S E R V I C E N O T E

4349A 4-Channel High Resistance Meter

Modification to eliminate CPU hang up due to defective X'tal oscillators

DATE: 19 February 1993

Figure 1.

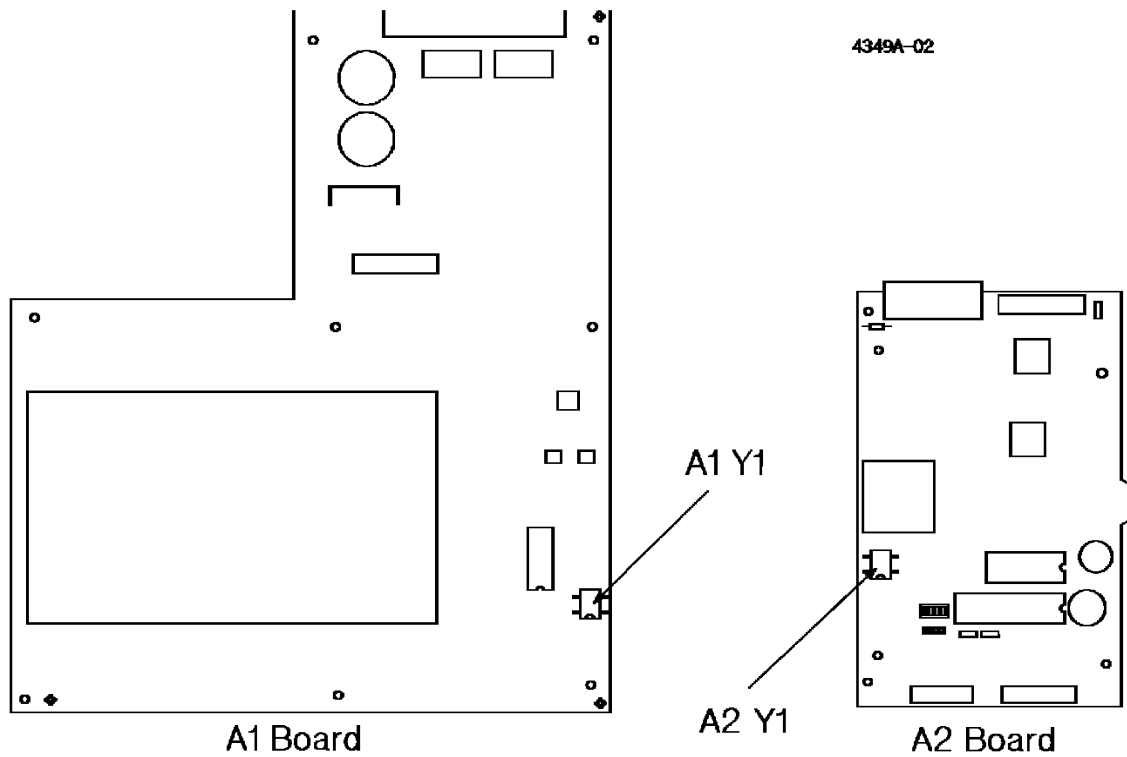
The 4349A units with serials given above may hang up intermittently. This is caused by the X'tal oscillator chip which has a problem in its manufacturing process. Two oscillator chips are used in the 4349A.

If the unit exhibits the symptoms given above, try replacing the two X'tal oscillator chips with new ones. These components are SMD (Surface Mounted Devices) but don't require any special tools or techniques to replace them. Their pin pitch is wider than the general SMD.

Figure 1. shows the X'tal location.

Part No.	Qty.	Ref Designator	Description
1813-0774	1	A1 Y1	X'tal Oscillator, 15.36 MHz
813-0708	1	A2 Y1	X'tal Oscillator, 16.0 MHz
